DART SERVICE INSTRUCTION

TO AMEND INSTALLATION INSTRUCTIONS IIN-D407-781-2 REV. A OR LATER APPROVED REVISION
AND INSTRUCTIONS FOR CONTINUED AIRWORTHINESS ICA-D407-781 REV. 3 OR LATER REVISION

REF. TCCA STC: SH08-60
REF. FAA STC: SR002726NY
REF. EASA.IM.R.S.01541

A	NEW ISSUE		13.04.08
REV.	DESCRIPTION	BY	DATE
DESIGN			
DRAWN			
CHECKED			
MFG. APPR.	N/A		
APPROVED			
DE APPR.			
DATE	13.04.08		
DART AEROSPACE LTD HAWKESBURY, ONTARIO, CANADA			
DRAWING NO. DSI 9649		REV. A SHEET 1 OF 2	
TITLE ALTERNATE INSTALL		SCALE NTS	
COPYRIGHT © 2013 BY DART AEROSPACE LTD. THIS DOCUMENT IS PRIVATE AND CONFIDENTIAL AND IS SUPPLIED ON THE EXPRESS CONDITION THAT IT IS NOT TO BE USED FOR ANY PURPOSE OR COPIED OR COMMUNICATED TO ANY OTHER PERSON WITHOUT WRITTEN PERMISSION FROM DART AEROSPACE LTD.

FIGURE 1 - D3879-1 BAGGAGE COMPARTMENT WALL PROTECTOR - ALTERNATE INSTALLATION

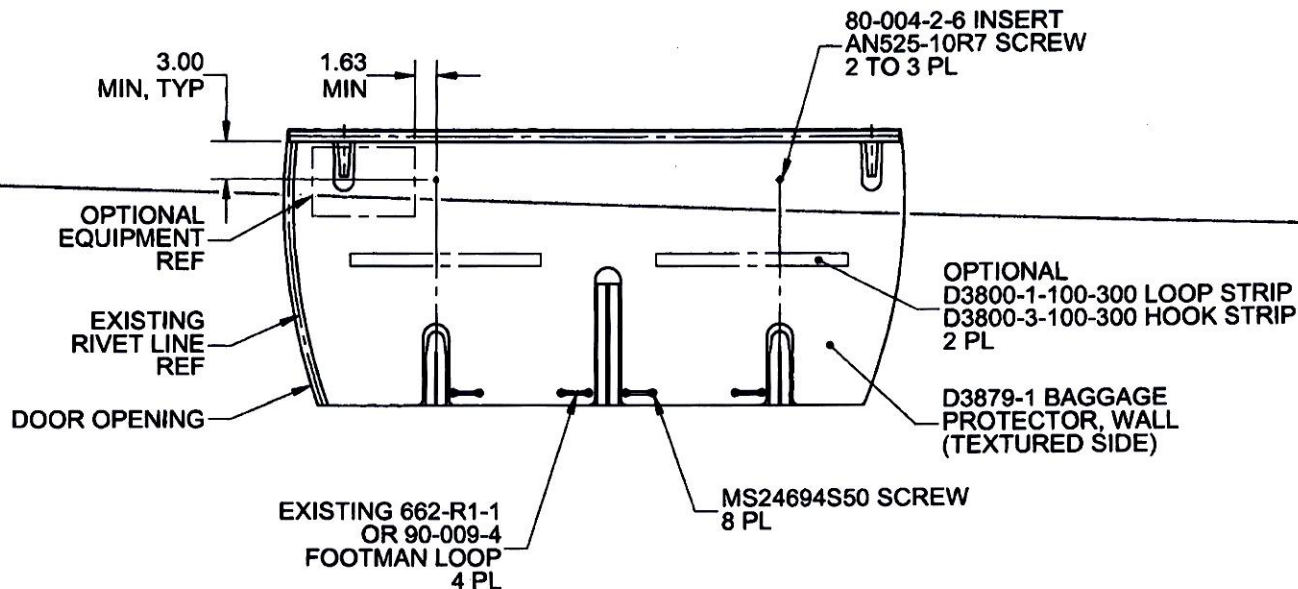
In some aircraft, the top portion of the D206-781-041 Baggage Compartment Wall Protector Kit cannot be installed as indicated in IIN-D407-781-2. The purpose of this DSI is to provide an alternate mounting method to fasten the top portion of the D206-781-041 Baggage Compartment Wall Protector Kit.

It is acceptable to replace qty(2) D3930-1 Clips with qty(2) 80-004-2-6 Inserts. Locate and mark location of the two attachment holes on the baggage compartment wall as shown in Figure 1 of this service instruction. Install 80-004-2-6 Inserts at the marked locations in accordance with Section 3-2-12 of BHT-206-SRM-1. It is acceptable to trim the wall protectors to accommodate optional equipment or transfer attachment holes to the wall protector and install the optional equipment on top of the wall protector with longer fasteners.

Qty -061	Qty -031	Qty -041	Part Number	Description
X			D206-781-061	BAGGAGE COMPARTMENT PROTECTOR KIT (FLOOR AND WALL)
1	X		D206-781-031	BAGGAGE COMPARTMENT FLOOR PROTECTOR KIT
1		X	D206-781-041	BAGGAGE COMPARTMENT WALL PROTECTOR KIT
		2	AN525-10R7	SCREW
		2	80-004-2-6	INSERT
